Newcastle Inner City Bypass

Rankin Park to Jesmond

Response to refined strategic design

Environmental Impact Statement

Figure 2: Design space – space to move.

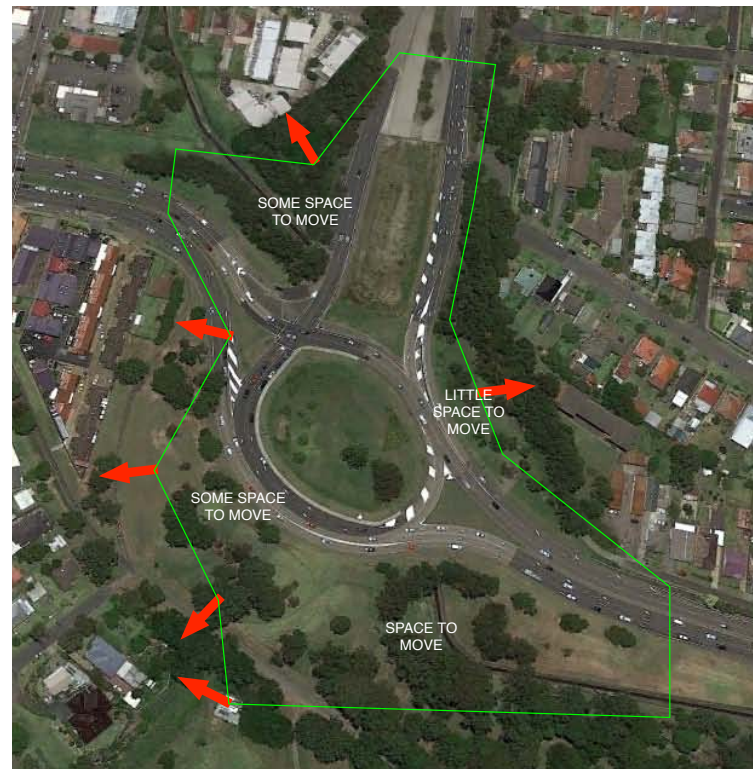
The design ignores the fact that on almost every corner of the current roundabout there is more room to accommodate the interchange, especially the area between Newcastle Road and the storm water drain north of Jesmond Park which is effectively a utilities corridor with no one living next to it. In Figure 2, I outline the design space that I believe ought to have been considered by the planners.

Figure 4: Modified design to reduce impact on local residents and better serve the needs of the Jesmond community. Also shown are bus lanes and relocated bus stops. Generally, traffic lanes are shown, not shoulders. The centre of the signalized area is indicated with a red dot.

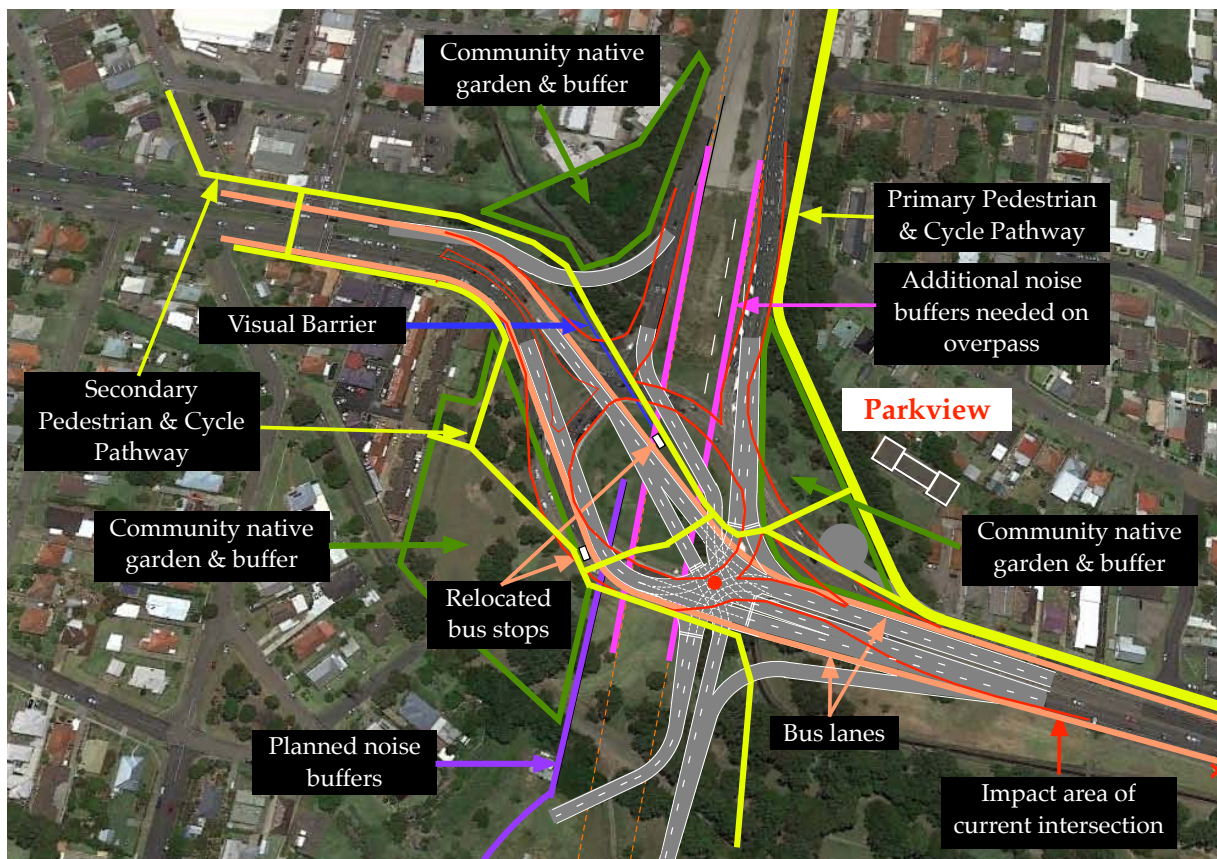
In Figure 4, I have used this IMPOSED, design to show how it can be modified to reduce its impact on local residents including Parkview, and better serve the needs of Jesmond.

The centre of the signalized intersection has been moved further south. This means that all of the lanes are moved away from Parkview. As it can be seen, much of the intersection can be catered for within the current disturbance area.

Generally, in the imposed design two lanes have been used approaching the signalization point which makes sense. It allows faster clearing of queues and a higher level of service for the intersection. However, the imposed design also shows doubling the left turn capacities which has no justification. If we need to double the capacity for vehicles turning left from the north into Newcastle Road heading towards Croudace Street, then there is no need for this stage of the bypass. The bypass is intended to largely eliminate this traffic and a significant level of that arriving along Newcastle Road from the Wallsend area.

In the interchange design the planners have incorporated noise buffers to the south-west but totally disregarded all other residents. The whole of the overpass must have noise buffers either side. In addition, if the IMPOSED design is used, the northeast part must be heavily buffered and the owners of Parkview compensated for loss of view.

Figure 5: Phasing plan for the proposed modified intersection linked to the bypass interchange. Where the vehicle or pedestrian/cycle movement is in red it is stop, in orange movement allowed if no conflict present, if green then go.

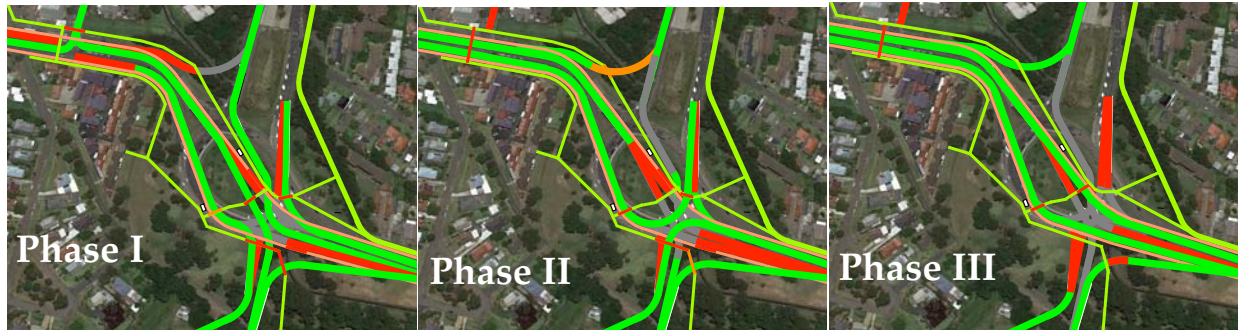
In Figure 5, I have indicated how the phasing of the intersection linked to the interchange and the Blue Gum Road junction could be phased to maximize the opportunity for 'green wave flow' both for vehicles and cycles. The precise timing for signal phases will need to be worked out by the engineers.
